LOT SPLIT for Chad Pawlikowski and Patricia Pawlikowski

SE QUARTER of SECTION 29, T-22-N, R-18-W
FRANKLIN TOWNSHIP, RICHLAND COUNTY, OHIO

Lot Split Application

LOT SPLIT for Chad Pawlikowski and Patricia Pawlikowski

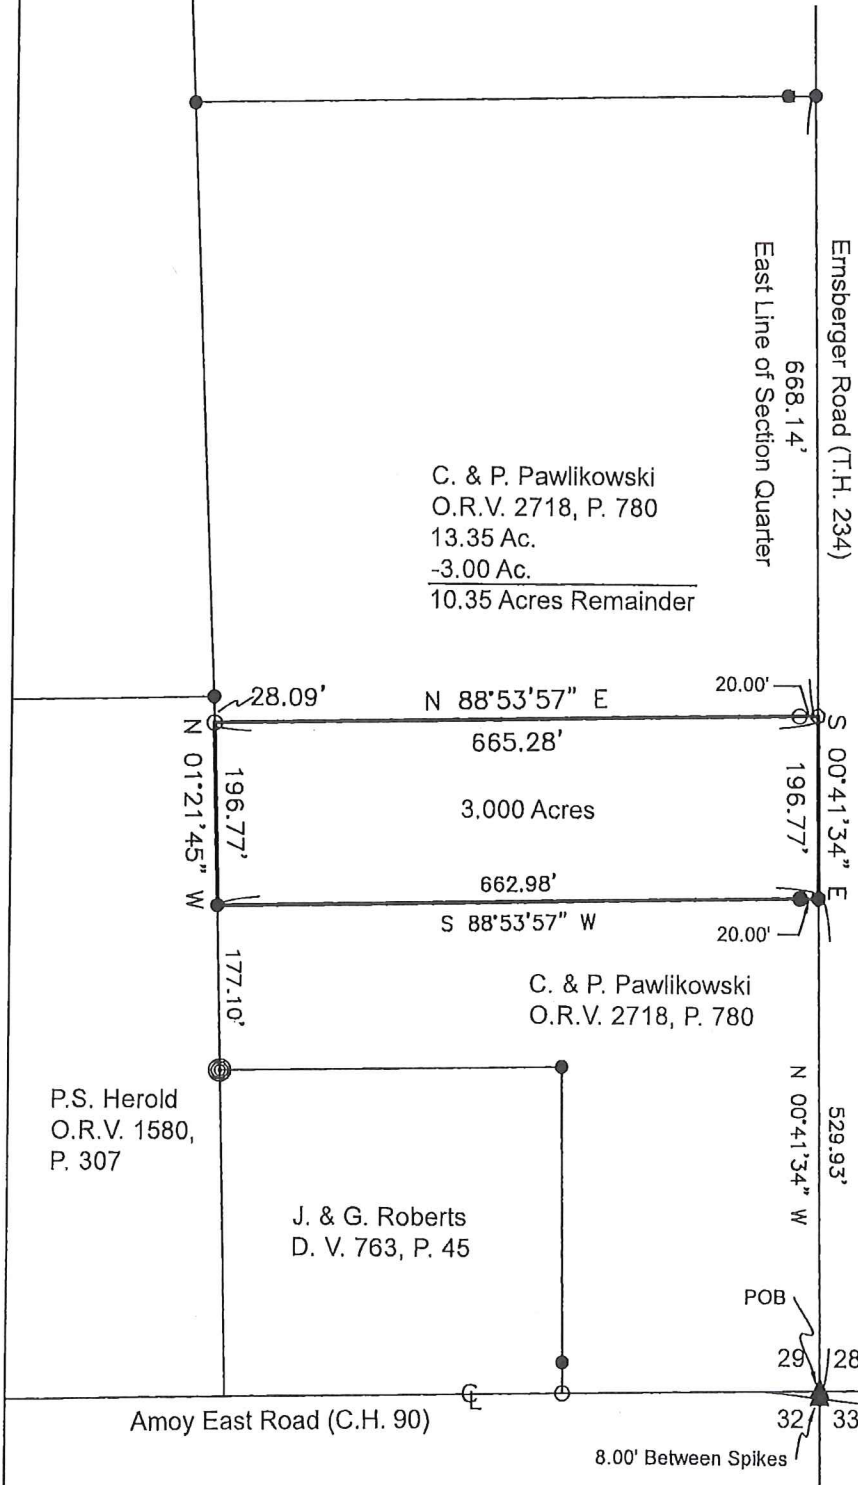
Comments: Lot 2 reviewed since it is under 5 acres. Information provided with the lot split application did not indicate any potential or existing utility easements. Areas designated for installation of septic system and the replacement area shall be undisturbed and protected from damage or disturbance. Note: Test hole 2 appears to be approx. 6' over the property line to the south. The indicated soil representation area is on part of this lot as well as part of the lot to the south.
